SERVICE BULLETIN

GLOBAL AFTER SALES OFFICE, MITSUBISHI MOTORS CORPORATION

PURPOSE : CHANGE	ISSUE NO. : MSB-14EXML00_54-001B	DATE : 2014-11-24
SUBJECT : RESET ESTIMATED INFORMATION AND CONTROL INFORMATION OF DRIVE BATTERY CAPACITY		<DESTINATION/MODEL> <M/Y> (MMNA/USTP/EUR/MMAL/ 11-14.5 NZ)
GROUP : GR:00(General)/54(Chassis Electrical)		i-MiEV(HA3W)/ Outlander PHEV(GG0W)

~~RESET ESTIMATED INFORMATION AND CONTROL INFORMATION OF DRIVE BATTERY CAPACITY <PHEV>~~

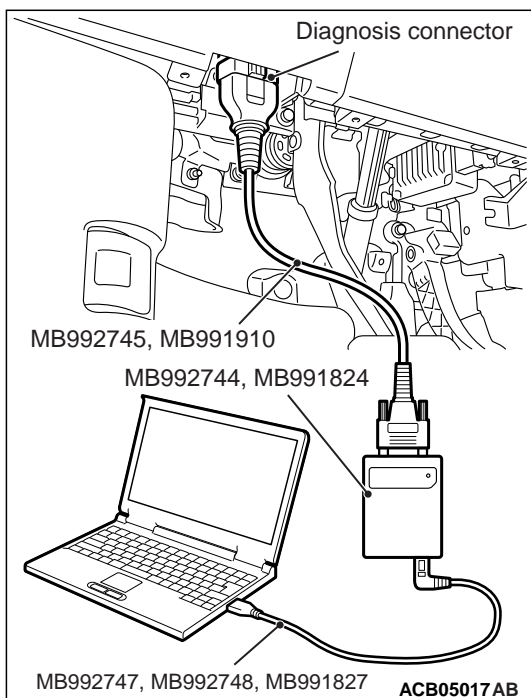
Do not execute "Batt. capa. estimated info. reset" unless you replace the drive battery and you determine the capacity of the battery, which is installed on an authorised used car.

- ~~Do not reset "Battery capacity estimated info" unless you replace the drive battery.~~
- If you did inadvertently, carry out the procedures for writing BMU learning value, and then execute the drive battery capacity automatic measurement (Refer to GROUP 54D–Battery Management Unit (BMU) and Traction Battery). <Old>

If replacing the drive battery, ~~reset~~ the drive battery capacity information and the control information. **initialise** <New>

1. Turn off the power supply mode of the electric motor switch. Then connect the M.U.T.-III to the diagnosis connector.
2. Turn on the power supply mode of the electric motor switch.
3. From the System select Screen of the M.U.T.-III, select the "BMU".
4. Select the "Special Function" from the BMU screen. <Old>
5. ~~Select the "Reset" from the Special Function screen~~
6. ~~Select the "Battery capacity estimated info" from the Reset screen, and reset.~~
7. ~~After the estimated information of the main battery capacity is reset, select "Control information" from the Reset Screen to reset.~~
8. Turn off the power supply mode of the electric motor switch, and then disconnect the M.U.T.-III.

5. Select the "Battery Maintenance Function" from the Special Function screen.
6. Select the "Batt. capa. estimated info. reset" from the Battery Maintenance Function screen.
7. Wait until "Batt. capa. estimated info. reset" has been completed. Then select "Control information reset" from the Battery Maintenance Function screen.

~~RESET ESTIMATED INFORMATION AND CONTROL INFORMATION OF DRIVE BATTERY CAPACITY~~

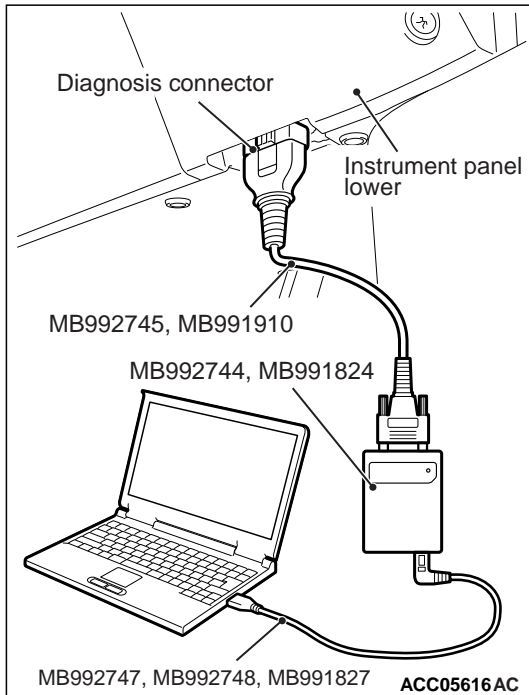
Do not execute "Batt. capa. estimated info. reset" unless you replace the drive battery and you determine the capacity of the battery, which is installed on an authorised used car.

- ~~Do not reset "Battery capacity estimated info" unless you replace the drive battery.~~
- If you did inadvertently, carry out the procedures for writing BMU learning value, and then execute the drive battery capacity automatic measurement (Refer to GROUP 54D–Battery Management Unit (BMU) and Traction Battery).

If replacing the drive battery, ~~reset~~ the drive battery capacity information and the control information. **initialise** <New>

- Turn off the power supply mode of the electric motor switch. Then connect the M.U.T.-III to the diagnosis connector.
- Turn on the power supply mode of the electric motor switch.
- From the System select Screen of the M.U.T.-III, select the "BMU".
- Select the "Special Function" from the BMU screen. <Old>
- ~~Select the "Reset" from the Special Function screen~~
- ~~Select the "Battery capacity estimated info" from the Reset screen, and reset.~~
- ~~After the estimated information of the main battery capacity is reset, select "Control information" from the Reset Screen to reset.~~
- Turn off the power supply mode of the electric motor switch, and then disconnect the M.U.T.-III.

- Select the "Battery Maintenance Function" from the Special Function screen.
- Select the "Batt. capa. estimated info. reset" from the Battery Maintenance Function screen.
- Wait until "Batt. capa. estimated info. reset" has been completed. Then select "Control information reset" from the Battery Maintenance Function screen.

INITIALISE ESTIMATED INFORMATION AND CONTROL INFORMATION OF MAIN BATTERY CAPACITY (BATTERY MAINTENANCE FUNCTION)

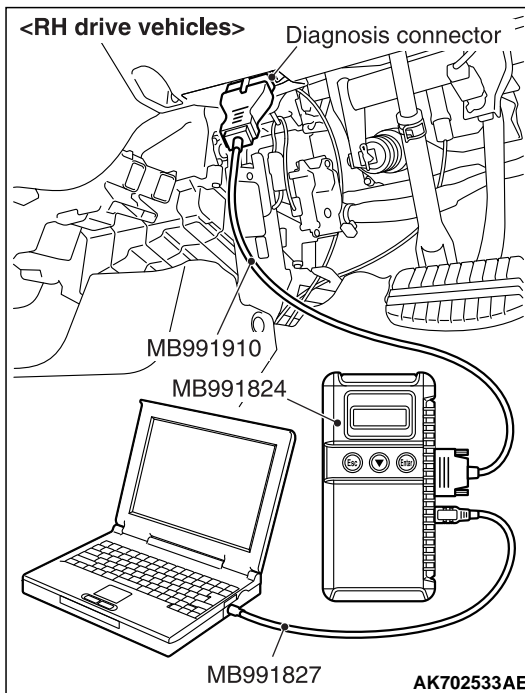
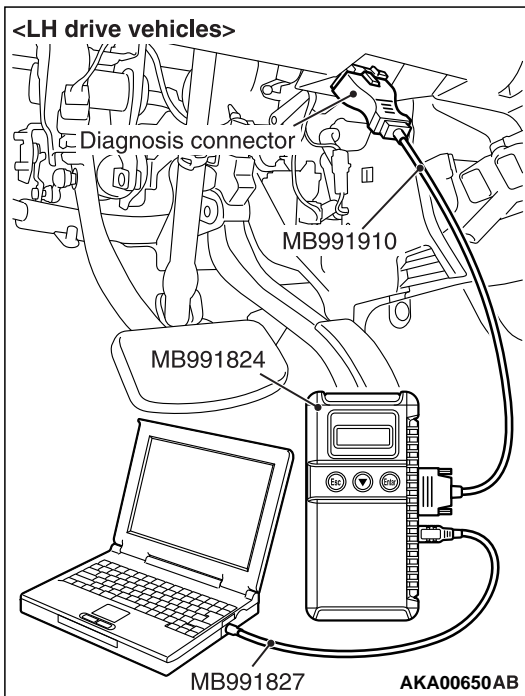
If replacing the main battery, ~~reset~~ the main battery capacity information and the control information.

- Do not execute "Batt. capa. estimated info. reset" unless you replace the drive battery and you determine the capacity of the battery, which is installed on an authorised used car.
- If you did inadvertently, carry out the procedures for writing BMU learning value, and then execute the main battery capacity automatic measurement (Refer to GROUP 54D-Main Battery Capacity Automatic Measurement)

3. From the System select Screen of the M.U.T.-III, select the "BMU".
4. Select the "Special Function" from the BMU screen. <Old>
5. ~~Select the "Reset" from the Special Function screen~~

6. ~~Select the "Battery capacity estimated info" from the Reset screen, and reset.~~
7. ~~After the estimated information of the main battery capacity is reset, select "Control information" from the Reset Screen to reset.~~

8. Put the power switch in the LOCK (OFF) position.
9. After the ~~reset~~ initialise <New> of the BMU control information, check the battery current capacity according to the following procedures:

5. Select the "Battery Maintenance Function" from the Special Function screen.
6. Select the "Batt. capa. estimated info. reset" from the Battery Maintenance Function screen.
7. Wait until "Batt. capa. estimated info. reset" has been completed. Then select "Control information reset" from the Battery Maintenance Function screen.

TRACTION BATTERY

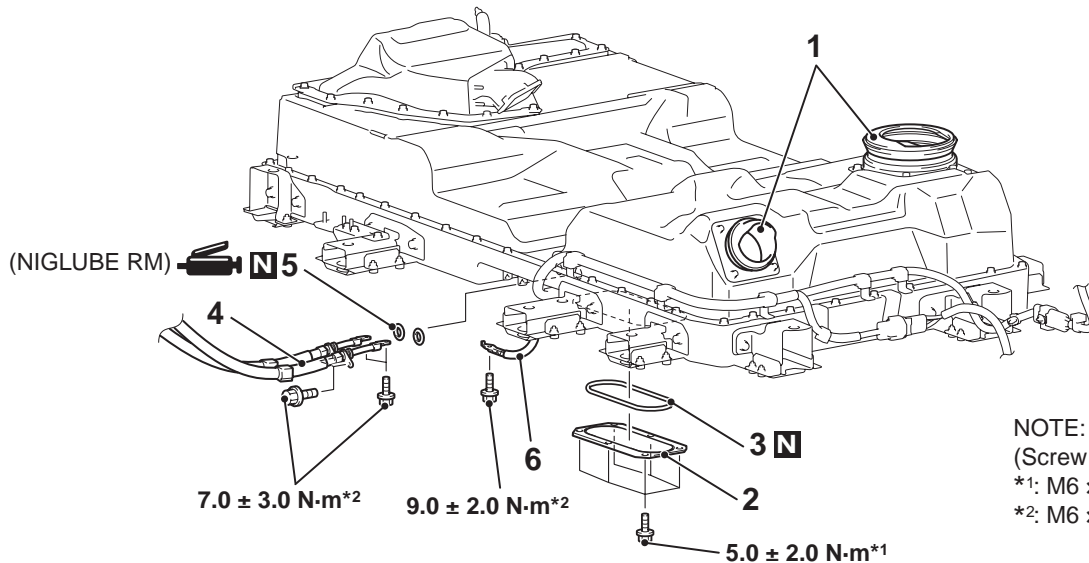
- ~~If the traction battery is replaced, use the M.U.T.-III to reset the traction battery capacity estimation information and control information (Refer to GROUP 00 – Precautions before Service, Reset Estimated Information and Control Information of Traction Battery Capacity).~~

- If the traction battery is replaced, use the M.U.T.-III to initialise the traction battery capacity estimation information and control information (Refer to GROUP 00 - Precautions before Service, Initialise Estimated Information and Control Information of Traction Battery Capacity).

INITIALIZE ESTIMATED INFORMATION AND CONTROL INFORMATION OF MAIN DRIVE LITHIUM-ION BATTERY CAPACITY (BATTERY MAINTENANCE FUNCTION)

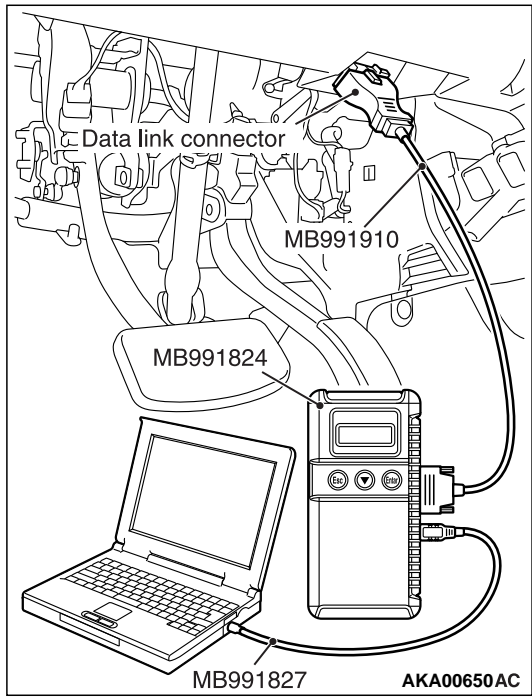
- Do not execute "Batt. capa. estimated info. reset" unless you replace the drive battery and you determine the capacity of the battery, which is installed on an authorised used car.
- If you did inadvertently, carry out the procedures for writing BMU learning value, and the then execute the main battery capacity automatic measurement (Refer to GROUP 54D-Main Battery Capacity Automatic Measurement)

If replacing the Main Drive Lithium-ion Battery, ~~reset~~ the Main Drive Lithium-ion Battery capacity information and the control information.

1. Connect the scan tool MB991958 to the data link connector with the electric motor switch in the "LOCK" (OFF) position.
2. Turn the electric motor switch to the ON position.
3. From the System select Screen of the scan tool MB991958, select the "BMU".
4. Select the "Special Function" from the BMU screen. <Old>
5. Select the "Reset" from the Special Function screen
6. Select the "Battery capacity estimated info" from the Reset screen, and reset.
7. After the estimated information of the Main Drive Lithium-ion Battery capacity is reset, select "Control information" from the Reset Screen to reset.

5. Select the "Battery Maintenance Function" from the Special Function screen.
6. Select the "Batt. capa. estimated info. reset" from the Battery Maintenance Function screen.
7. Wait until "Batt. capa. estimated info. reset" has been completed. Then select "Control information reset" from the Battery Maintenance Function screen.

MAIN DRIVE LITHIUM-ION BATTERY

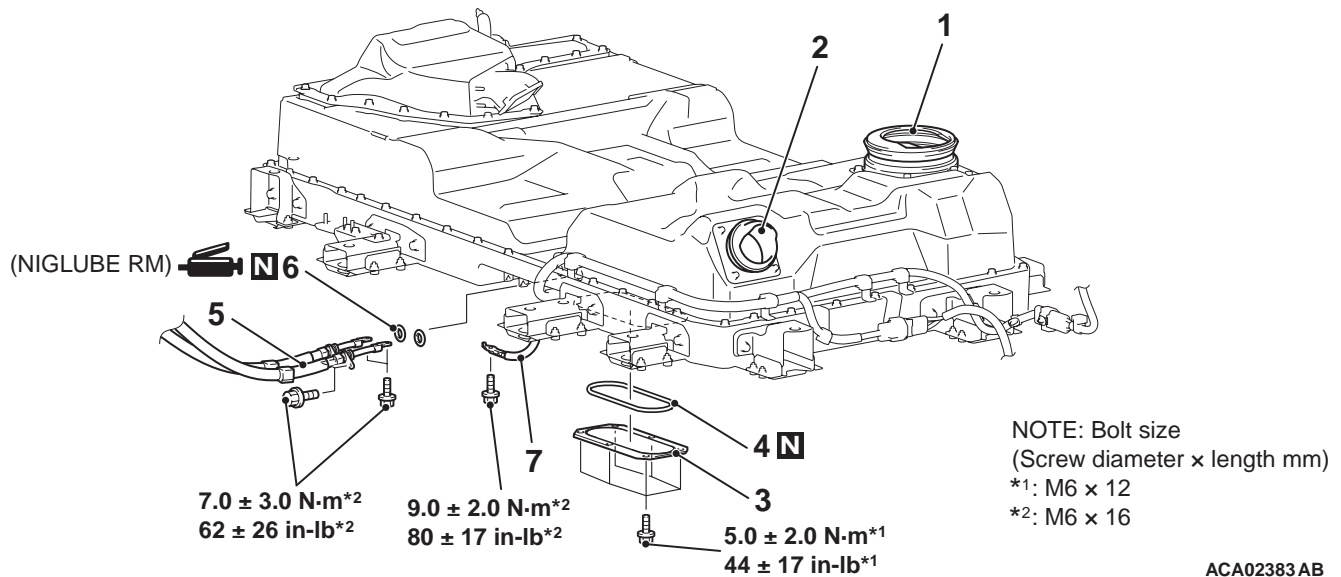
- ~~After replacing the Main Drive Lithium-ion Battery, use the scan tool to reset the Main Drive Lithium-ion Battery capacity estimation information and control information.(Refer to GROUP 00 – Reset Estimated Information and Control Information of Main Drive Lithium-ion Battery Capacity .)~~

If the Main Lithium-ion Battery is replaced, use the scan tool MB991958 to initialize the Main Lithium-ion Battery capacity estimation information and control information (Refer to GROUP 00 - Precautions before Service, Initialize Estimated Information and Control Information of Main Lithium-ion Battery Capacity).
